# Modification to Street Right of Way dimension standards

## Highland Oaks Unit 6

Planning  
Commission  
August 18, 2021

**Plat of  
HIGHLAND OAKS UNIT 6  
SUBDIVISION**

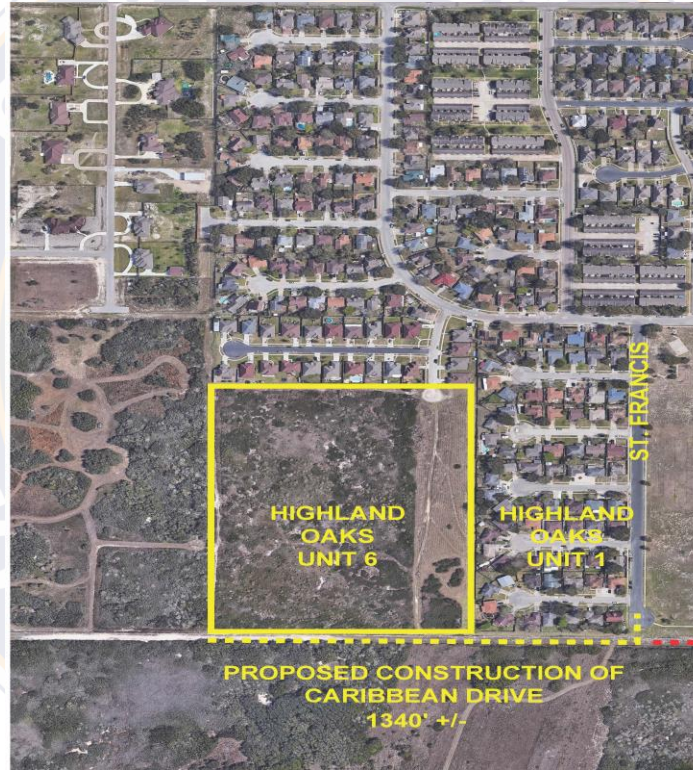
1. The property's boundary is on the Urban Transportation Plan.
2. The UTP has Caribbean Drive as a C1 60-foot street with a 40-foot back to curb pavement width, which connects two Arterials, Waldron Road and Flour Bluff Drive.

**Approval** of the modified street section providing for a paved 28 foot wide back to back paved street with a five foot sidewalk on the development side of the street.
